13023 Greenwood Avenue North DPD# 3004905

June 9, 2008

Foss Home and Village

DESIGN REVIEW RECOMMENDATIONS OF THE
NORTHWEST DESIGN REVIEW BOARD

Building 9 East Elevation

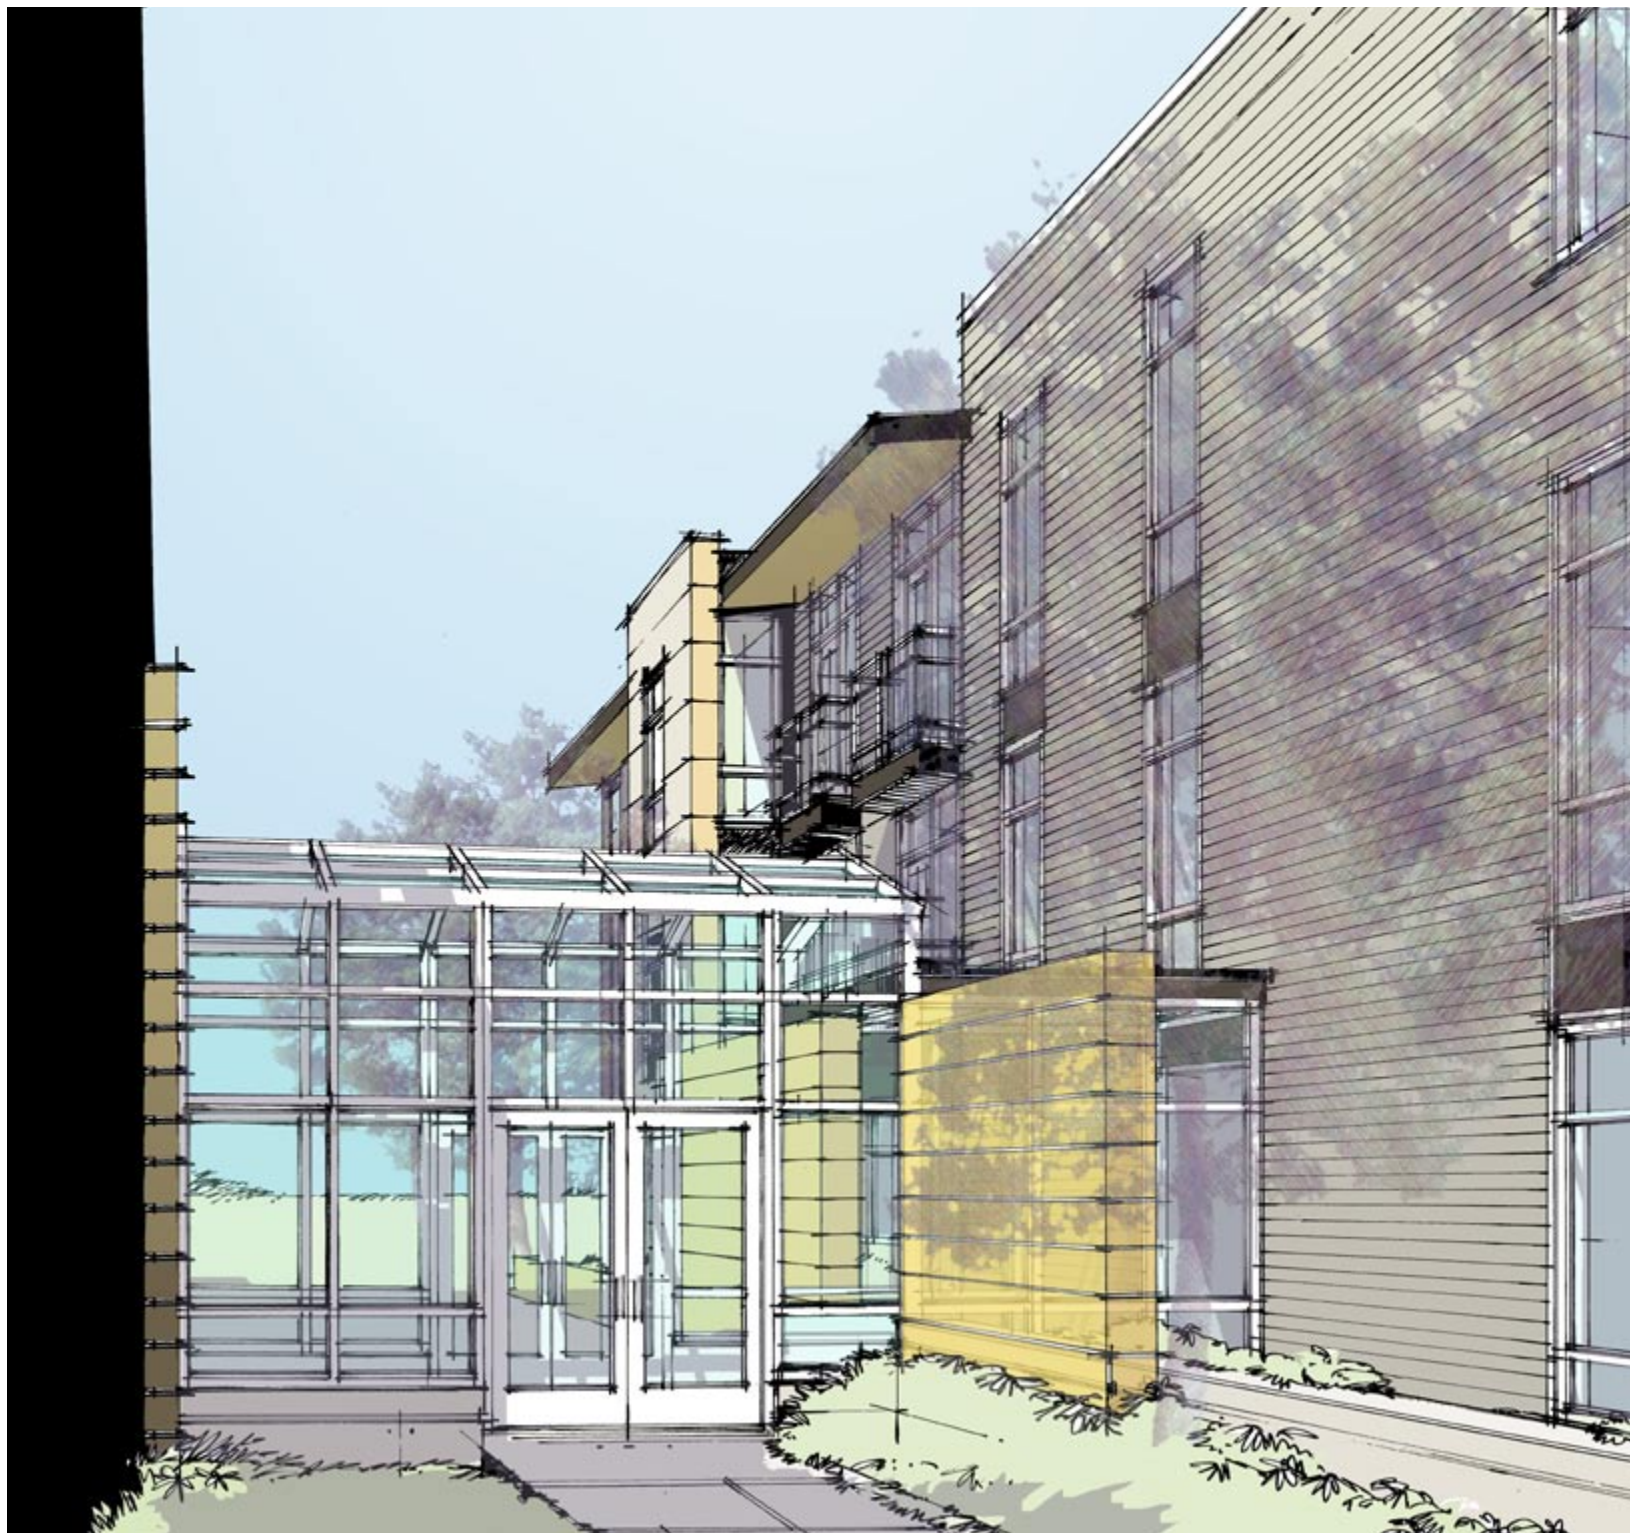
- 1. Building Scale. (A-5, B-1, C-1, C-3, D-1)
 - a. The Board felt that the proposed Building 8 and 9 should be modified to better meet the design guidelines. A combination of additional residential texture, modified materials and colors, façade modulation, reduced building footprints, and increased setbacks from property lines should be incorporated.

- 2. Pedestrian Experience (A-2, A-3, A-7, A-10, B-1, C-3, D-1)
 - a. Buildings 8 and 9 should be designed to provide a more residential, articulated, and pedestrian-friendly façade along Greenwood Avenue North. Increased and/or staggered setbacks, reduced building footprints, modified materials and colors, and/or modulation along the Greenwood Avenue North front façade may be tools to enhance the residential texture and create more adjacent open space to match the cant of Building 1. This is essential in maximizing the pedestrian experience along Greenwood Avenue North

The Design review Board felt that Buildings 8 and 9 in particular should be modified to better meet the Design Guidelines. This typical elevation (Building 8 is similar) illustrates the changes proposed.

floating bay elements expressed as projected frames, and clad in rainscreen panel siding typical

brick masonry substituted for metal siding at largest buttressing masses

added decks, balconies and railings provide tactile interest and variety at central division of building mass

roof modified to slope toward street edge and raingarden

larger windows at upper floors, typical

stack-bond CMU siding replaced with horizontal siding and horizontal battens, similar to illustration.

“phone booth” elements within connecting bridges removed -- expressed as small, transparent “bump” on second floor only, and screened by open trellis similar to new horizontal siding

note that gates have been pulled forward of building wall, creating additional layering, and are expressed as separate elements belonging to each of the “houses”

connecting link at Buildings 4 and 5

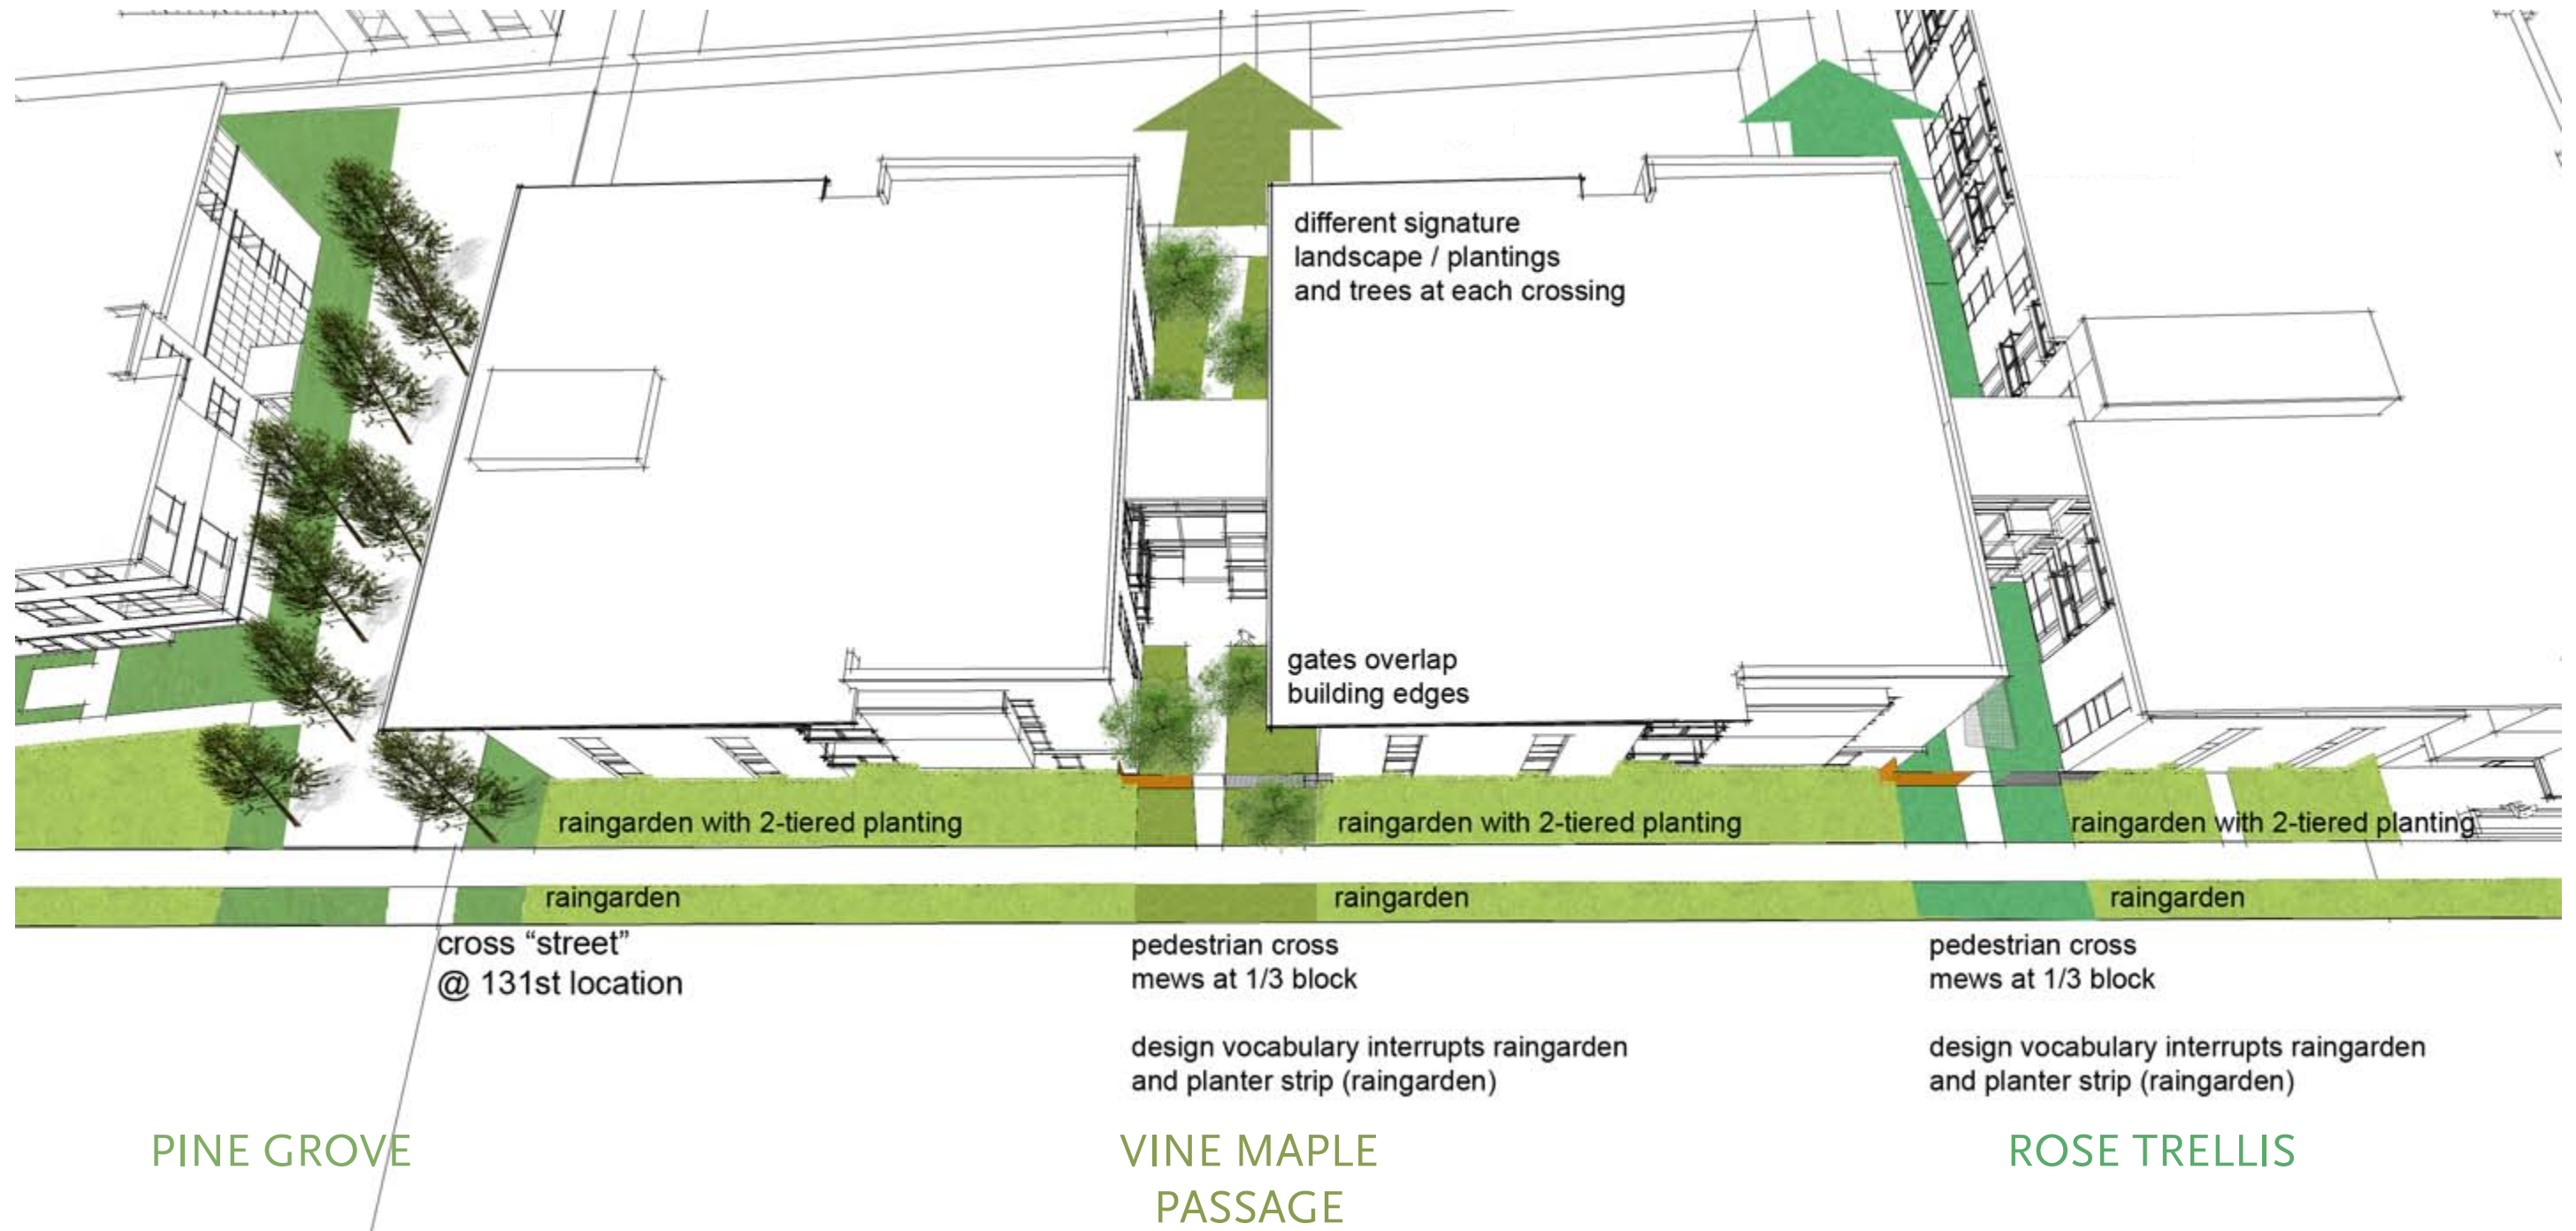
- b. The connector corridors should be lowered in height, such that a distinct break in height is apparent between the connectors and the proposed structures.

The connecting link joining Buildings 4 and 5 represents a Design Departure, and has been expressed as a transparent “greenhouse” per discussions with planning staff. The southern portion adjoining Building 4 is wider and terminates in a wall screening Building 4’s public areas from the resident terraces of Building 5. A continuation of this wall is proposed to provide further screening of this nature, as well as to strengthen the architectural quality of this element. The design vocabulary for this wall is a further hybrid of the horizontal siding from Building 9 -- with the battens removed to allow plants to climb the walls.

1 WIDTH - DEPTH ANALYSIS

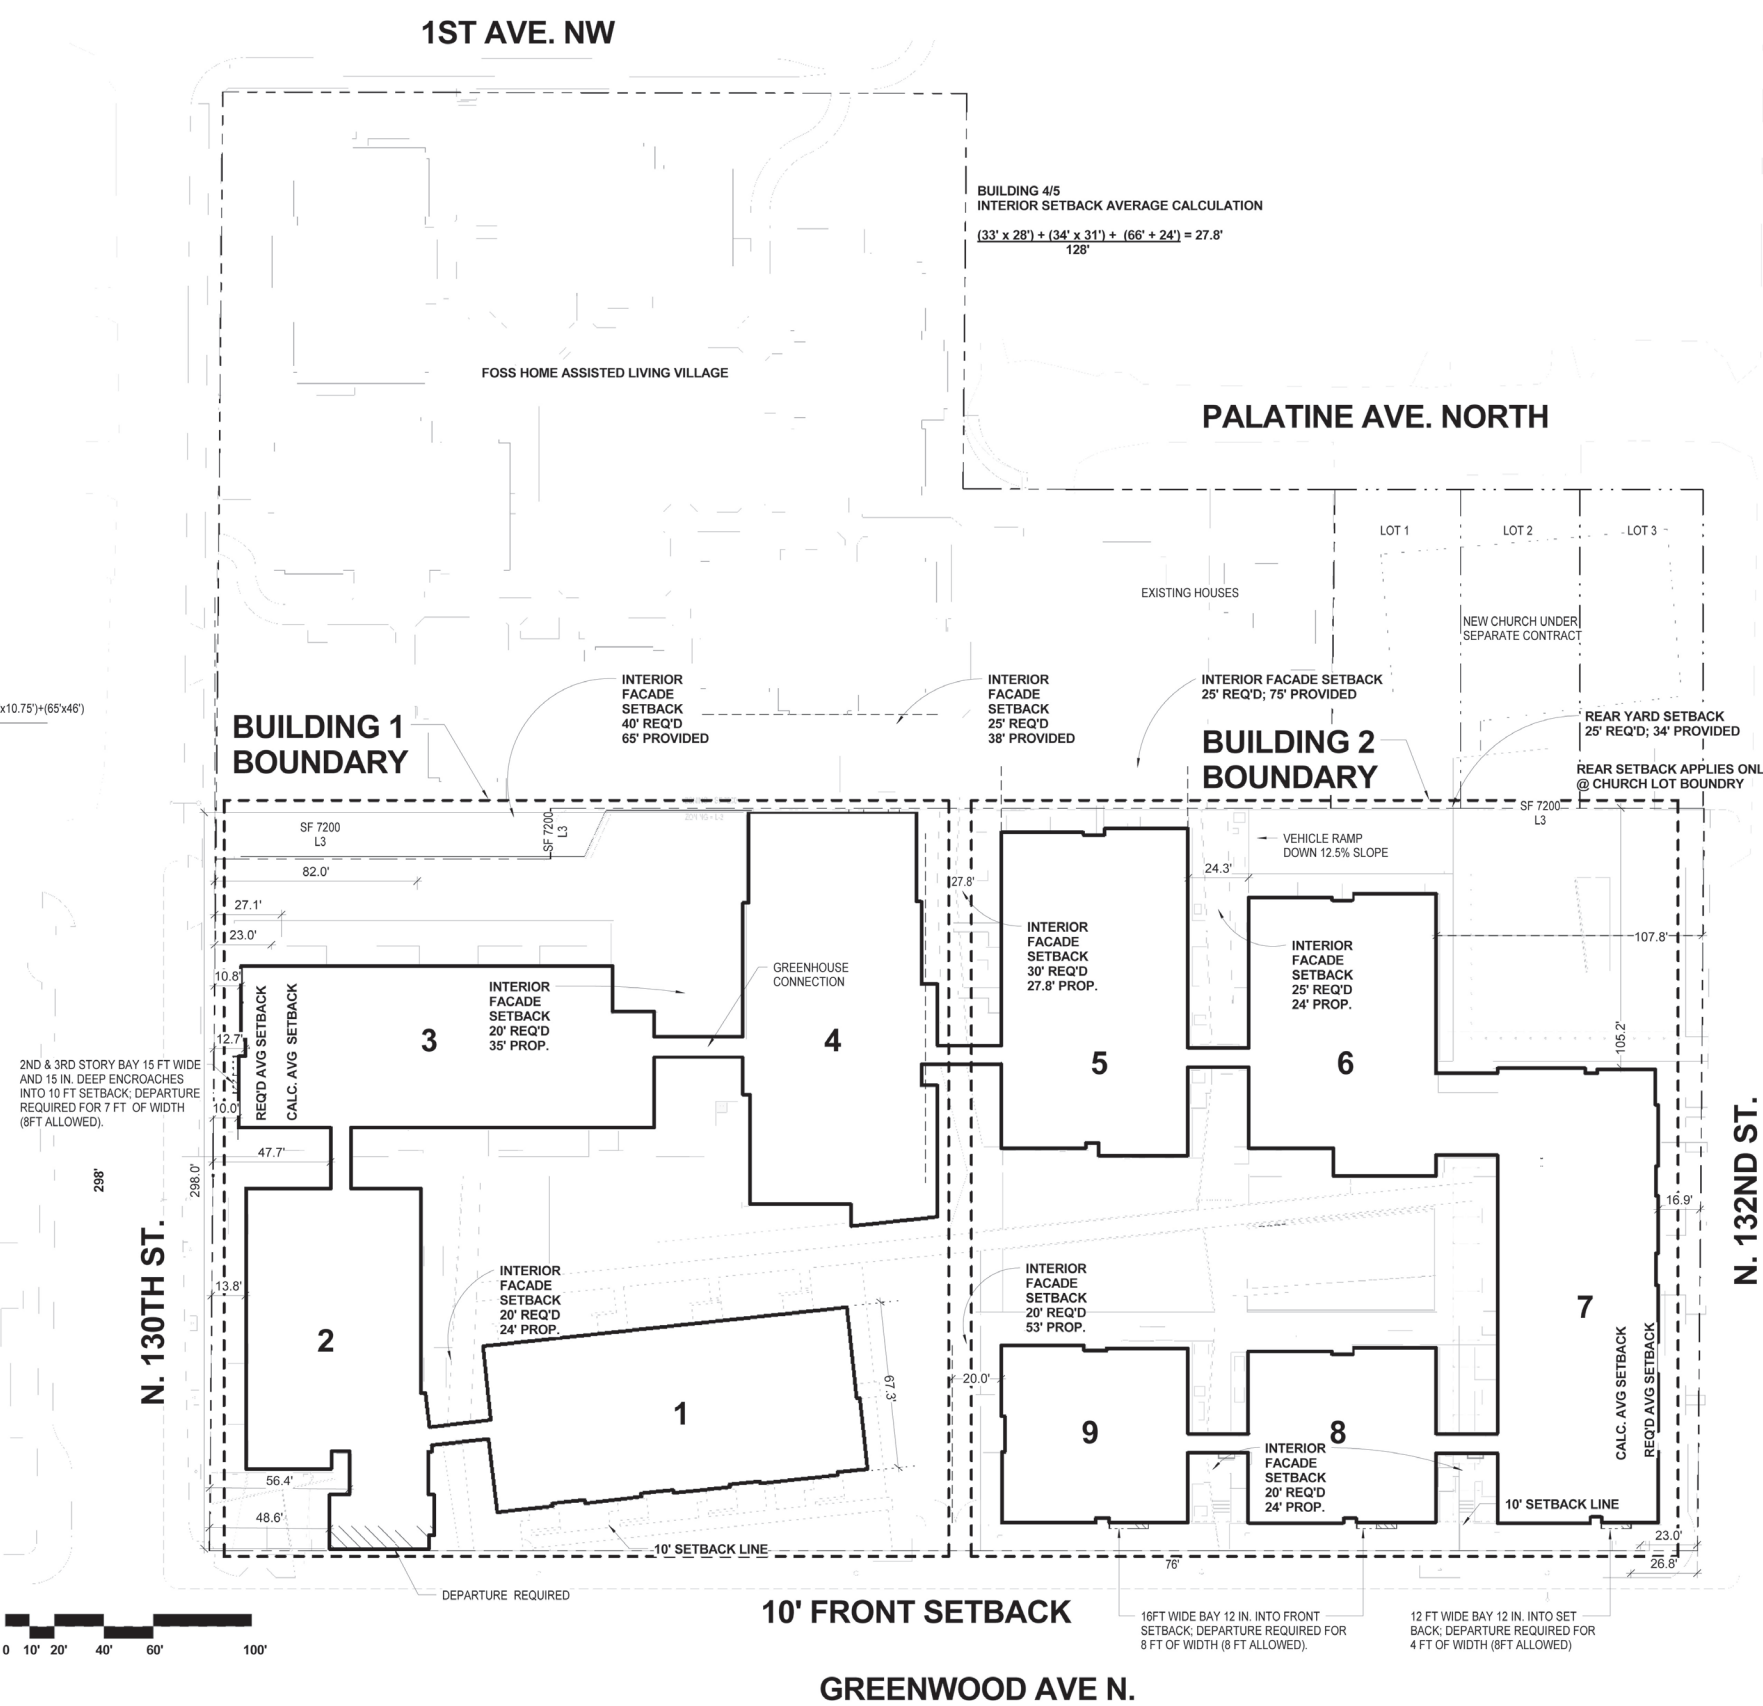
- b. Departures for building width and depth are significant
 - c. Departures appear more supportable for building setbacks and building modulation.
 - d. Departures for lot coverage would be more supportable if the applicant demonstrated that proposed departure better meets the intent of the design guidelines through enhanced design and/or massing tradeoffs in other areas rather than larger building footprints (ex. increased lot coverage departure combined with increased setbacks, increased modulation, enhanced residential texture for Buildings 8 and 9 Greenwood Avenue North along).

- WIDTH AND DEPTH OF BUILDING 1 & 2 SIGNIFICANTLY EXCEEDS ALLOWABLE WIDTH & DEPTH AND WILL REQUIRE A DEPARTURE BASED ON DIVIDING THE BUILDING VISUALLY USING 3 STORY TRANSPARENT CORRIDORS.
- SINGLE STORY CORRIDORS BETWEEN STRUCTURES 3 & 4 AND STRUCTURES 4 & 5.

2ND & 3RD STORY BAY 15 FT WIDE AND 15 IN. DEEP ENCROACHES INTO 10 FT SETBACK; DEPARTURE REQUIRED FOR 7 FT. OF WIDTH (8FT ALLOWED).
